Docket No. 52-021  
MHI Ref: UAP-HF-10266

**Subject: MHI's Response to the NRC's Request for Additional Information on Topical Report MUAP-07013-P (R1) "Small Break LOCA Methodology for US-APWR" on 09/28/2010**

**MHI's Response to the NRC's Request for Additional Information  
on Topical Report MUAP-07013-P (R1)  
"Small Break LOCA Methodology for US-APWR" on 09/28/2010**

Figure RAI-1.1 Break Flow Rate

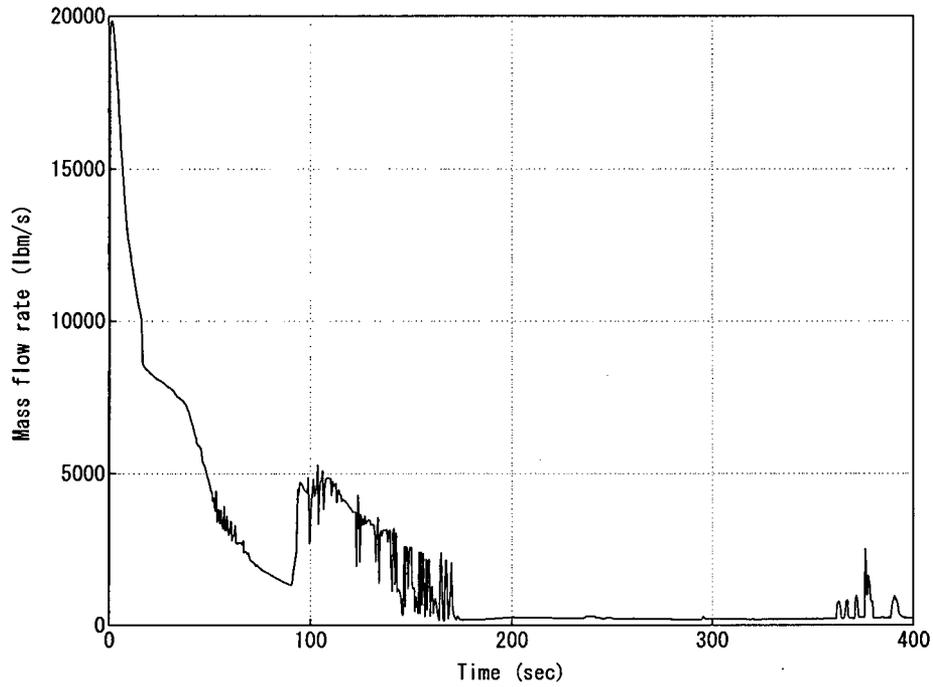
Provide a description of the code changes made to the break flow model, the source code for version 1.6, the PC Windows executable for version 1.6 and plots of break flow and PCT versus time for the limiting SBLOCA case. Confirm that version 1.6 includes an edit that identifies which critical flow model is being used at any time to facilitate confirmation that the Moody model is being used as required by Appendix K. In addition to adding a minor edit/plot variable, a good way to display this information in a major edit would be to print out a count of how many times each critical flow correlation was used since the last major edit.

Details of the code modification are described in Enclosure 4 of this document. The source code and PC-windows executable for M-RELAP5 M1.6 are in Enclosure 6 (OSM). The plots of break flow and PCT versus time for the limiting SBLOCA case (bottom of cold leg 1-ft<sup>2</sup> break) are shown in Figure RAI-1.1 and 1.2, respectively. The edit of the critical flow model flag is shown in Figure RAI-1.3. [
